**Enclosure 2**

**MFN 14-075**

**GEH Response to RAI 02-1**

**ABWR DCD DRAFT Revision 6 Markups**

Figure 2.15.5i Reactor Building Safety-Related Diesel Generator HVAC System

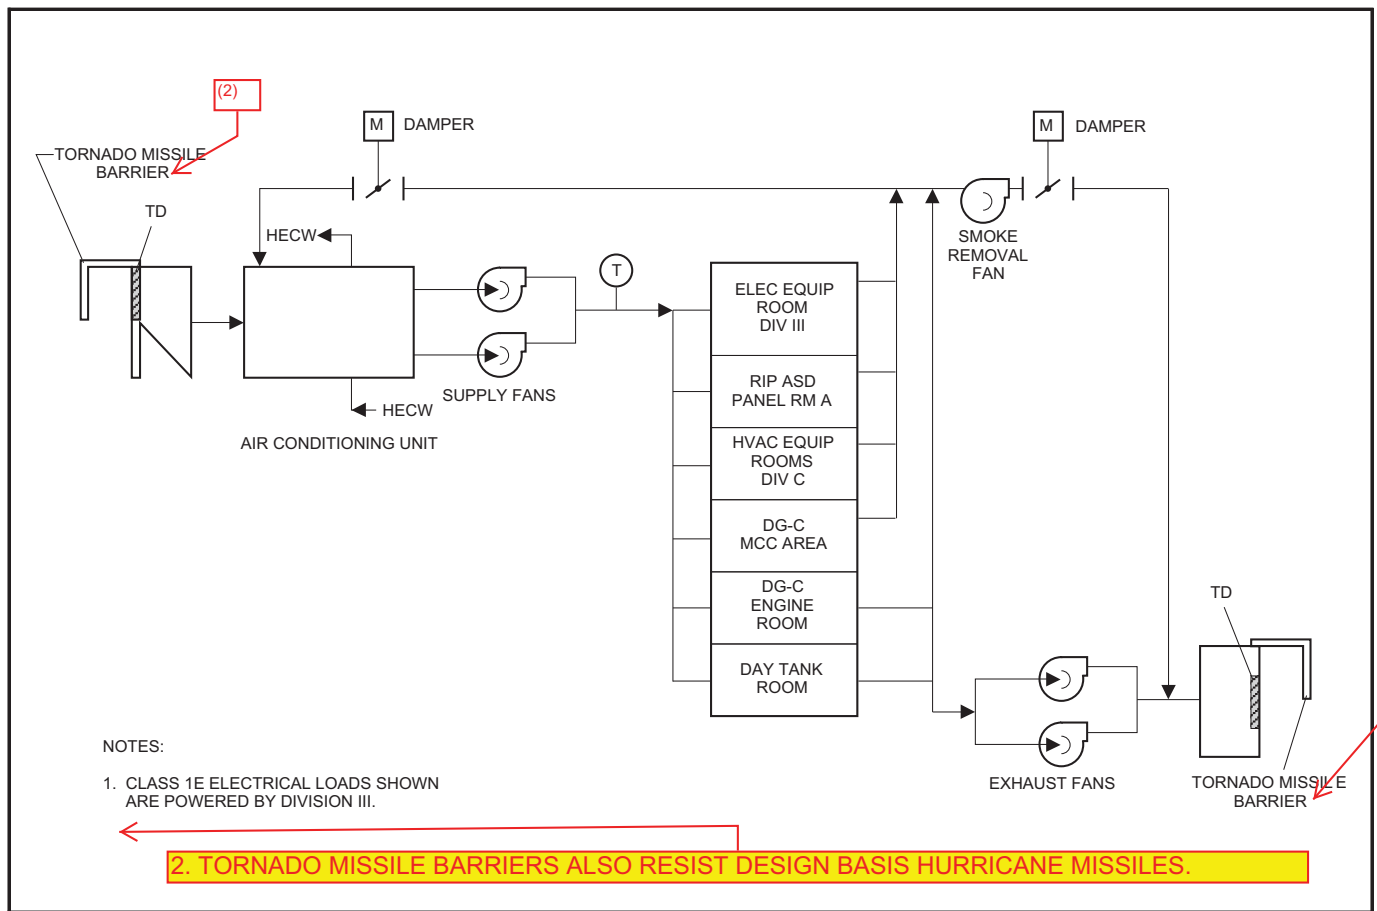
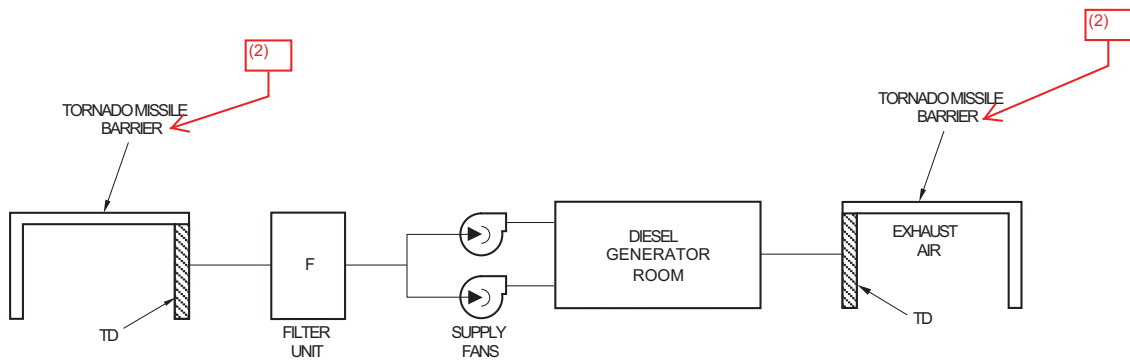
2. TORNADO MISSILE BARRIERS ALSO RESIST DESIGN BASIS HURRICANE MISSILES.
